PPRP Exhibit__(HS-5)

BGE Responses to Selected Non-Confidential Data Requests

Case No. 9600
Baltimore Gas and Electric Co.
Response to PPRP Data Request 1
Request Received: 04/24/2019
Response Date: 05/08/2019

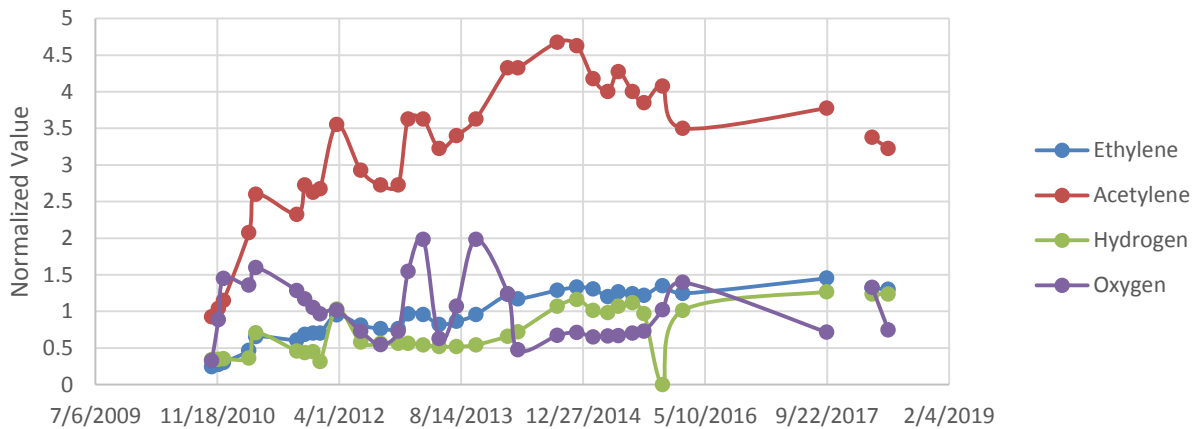
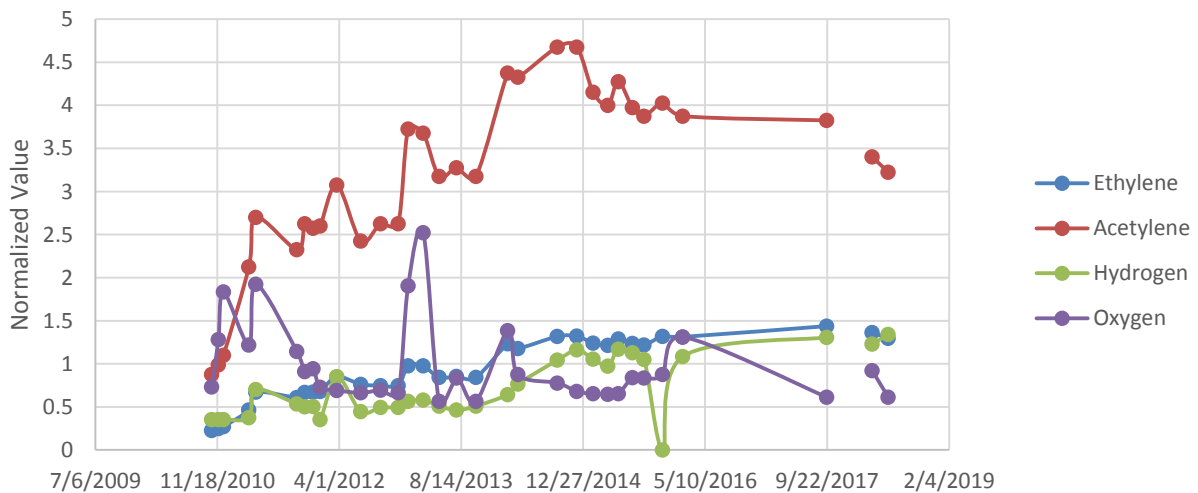
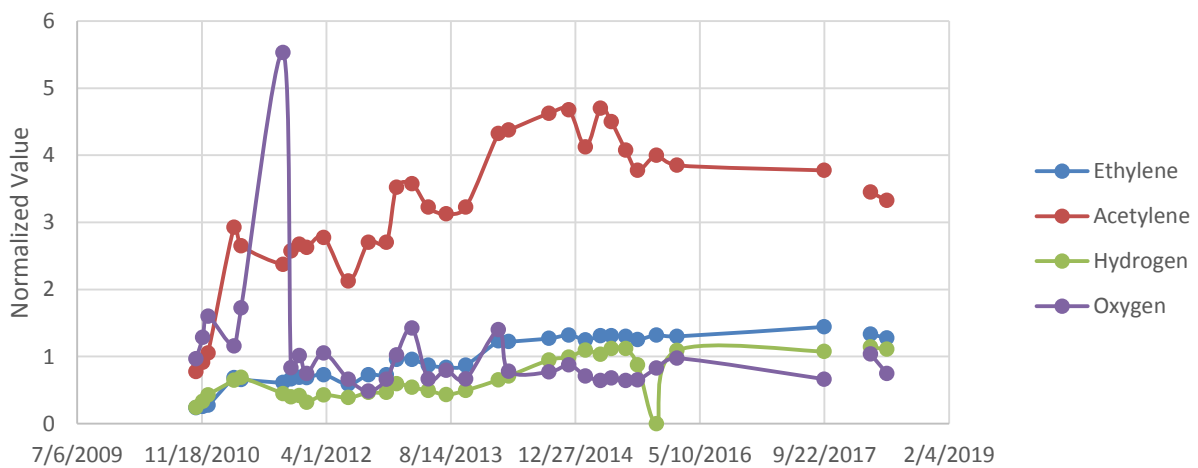
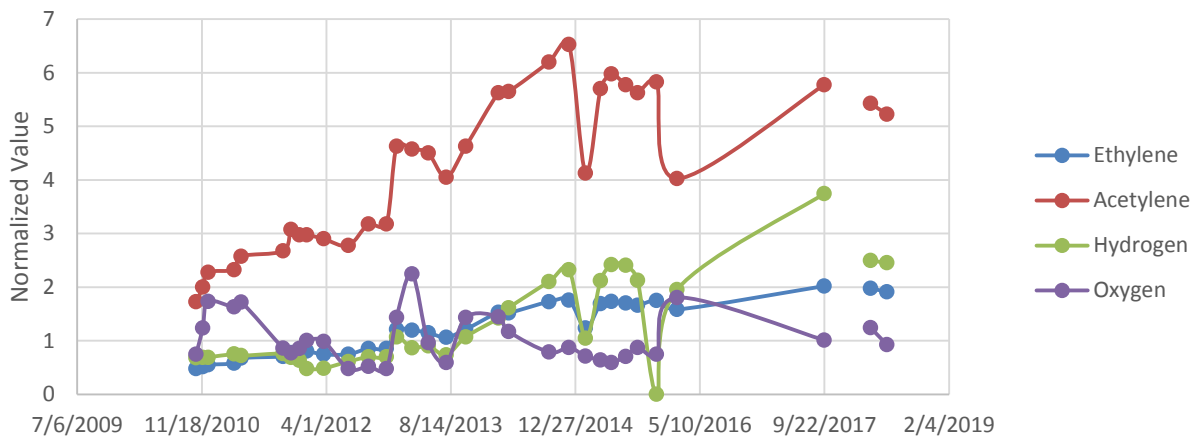
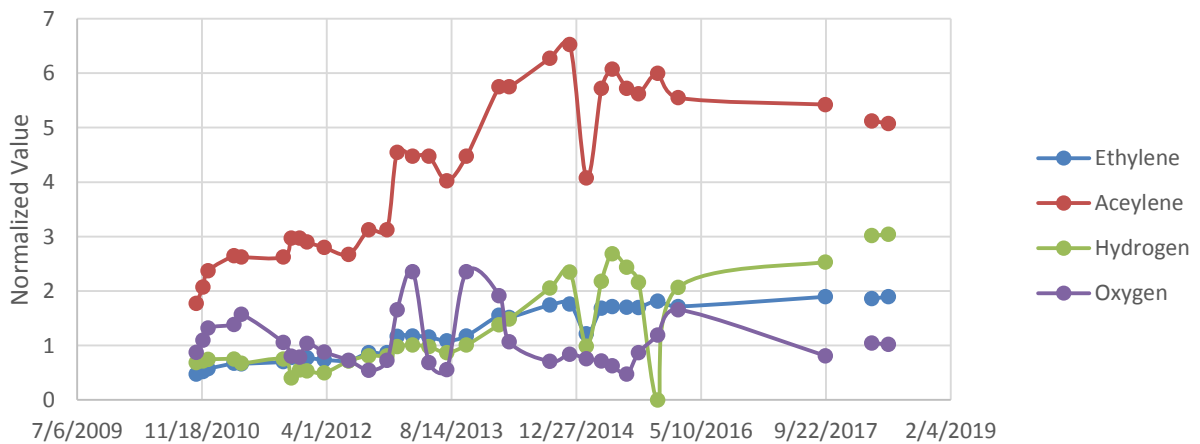
The discussion on pages 4-5 of the Application indicates that tests have shown that the levels of combustible gases have been rising over time. Please provide a graph or table showing the test dates and the observed dissolved gas concentrations.

Table 9—Guidelines for levels of gases found by DGA in HPFF cable systems

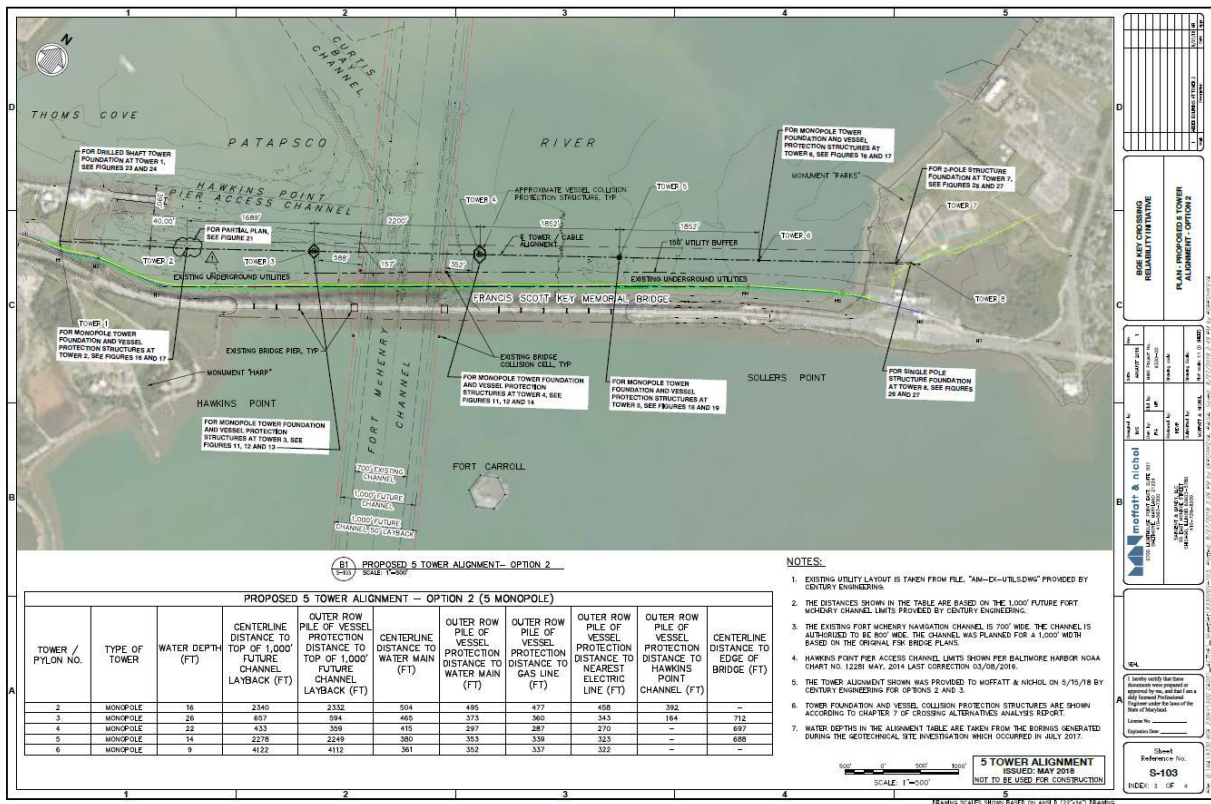
On page 14 of the CPCN Application, BGE states that the existing transmission line right-of-way (ROW) has a width varying between 70 and 180 feet. Sizes of the ring protection structures for the monopole configuration found in Environmental Review Document, Figures 3.2-21 and 3.2-22, are approximately 133 Ft x 201 Ft (Tower 4) and 154 Ft x 256 Ft (Tower 5), with the longer dimension oriented perpendicular to the ROW. Thus, the protection structures would appear to be wider than the maximum width of the ROW.

- a) Will the monopole foundations be located in the center of the ROW?
- b) Will the protection structures extend beyond the ROW boundary at any point?
- c) Will BGE need to expand the ROW to accommodate the protection structures?
- d) Please provide a diagram for each tower location showing the pole center point, the existing utility (cable) corridor, the extent of the pole foundation, and the outer extent of the associated protection structure, superimposed accurately on a map of the ROW boundaries at that location.

- c) Please see the response to (b) above.
- d) BGE has chosen to proceed with Option 2, the monopole option. Please refer to the Joint Permit Application ("JPA") in Appendix E of the Environmental Review Document. Within the JPA documentation, Appendix D contains the 30% design drawings. Within the 30% design drawings, please refer to reference sheet S-103, which shows the

proposed alignment for the monopole design (a snapshot appears below). On the bottom is a table describing the distances between the new line facilities and various existing features. The third column from the right lists the distance between the nearest existing underground electric cable and the nearest driven pile for the new line. This table indicates that the distance ranges between 270 feet at Tower 4 to 458 feet at Tower 2. As mentioned in the response to (a) and (b) above, the land-based ROW boundaries are not applicable to these in-water towers.
